**RE: Supplemental Waiver Request to Accompany Notice of Intent, 0 Maple Street, Plympton  
DEP File #SE266-0229**

## PEER REVIEW RESPONSE MEMO

**TO:** Plympton Conservation Commission  
**FROM:** Brad Holmes  
**DATE:** May 10, 2023  
**RE:** 0 Maple Street, Plympton DEP File #SE 266-0229

## SHEET 2

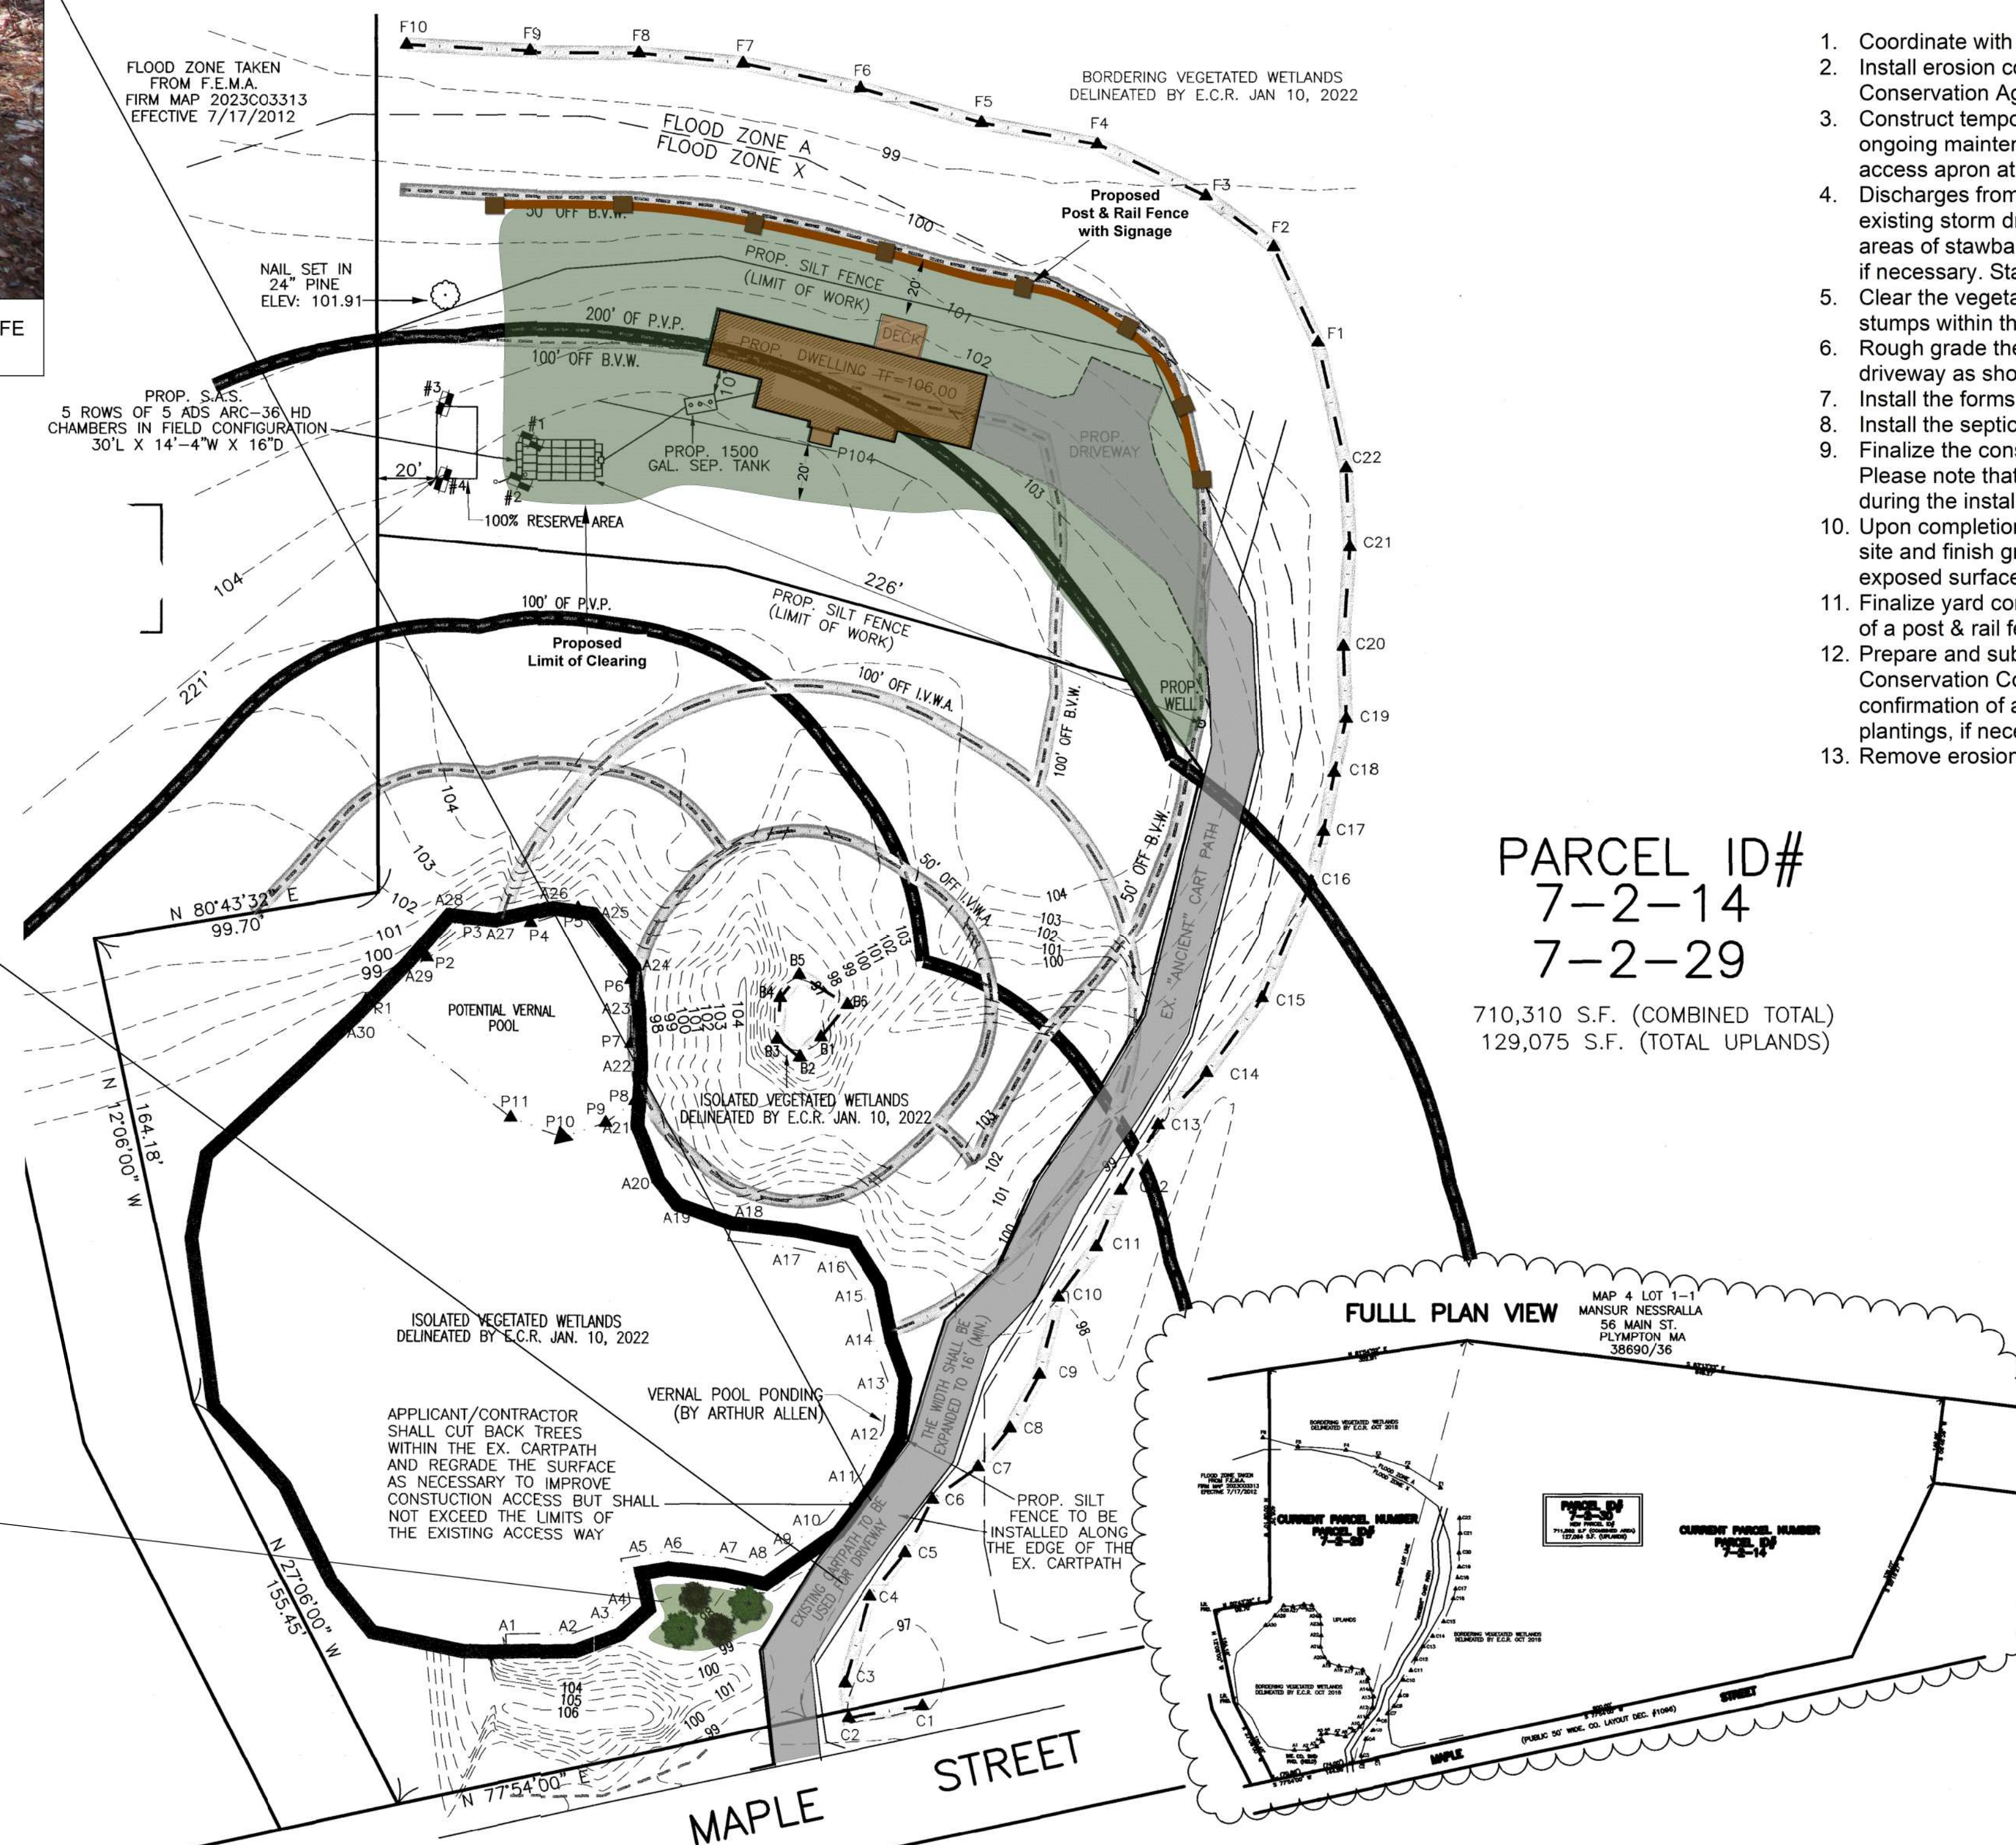
**EcoTec Comment & Recommendation #2b - The revised plan shows 100 and 200-feet off the Vernal Pool. The 200-foot offset is the Vernal Pool Buffer Zone limit. This limit encompasses the proposed septic system and cuts through the proposed house. No waiver for the 100-foot Vernal Pool buffer setback was requested. It will be difficult to justify work in this zone as the science for usage of the adjacent upland by vernal pool-dependent species is well established.**

**EcoTec Comment & Recommendation #2c - Additional driveway details and construction notes were provided. Tree clearing and re-planting have been specified. The driveway cross-section includes a 12-foot wide surface with 2-foot wide gravel shoulders for infiltration as well as temporary siltation fencing for erosion control. I am in agreement with the revised driveway construction and mitigation and agree that the net impacts should be no greater than the existing gravel carpath. As noted above, I do not agree with the proposed 12-inch "critter crossing" culverts under the driveway, particularly where they would require the driveway to be raised in order to provide cover over the culverts. It is my understanding that animals will**

**not typically enter small, dark culverts and would prefer to go up and over a low-profile driveway or roadway.**

**EcoTec Comment & Recommendation #3 – See section 2.b above. #3 refers to the 100 foot vernal pool limit, 100 foot vernal pool buffer zone, and no disturbance areas under the Plympton Wetland Bylaw Regulations.**

*Response - The project has been redesigned to move the house and yard as far away from the vernal pool as possible while leaving a reasonable development footprint. The proposal is to create a small, reasonable yard up to the 50 foot buffer zone to the northerly C & F series BVW. It is not possible to avoid work in the second 100 foot buffer zone or land within 100 feet of the vernal pool (Mean Annual High Water of the vernal pool plus 100 feet). The waiver request has been supplemented to include the proposed work within land within 100 feet of the vernal pool.*

*Response - The proposed critter crossings have been removed from the proposed project.*

*Response – The waiver request has been supplemented to include proposed work within land within 100 feet of the vernal pool and additional project information.*
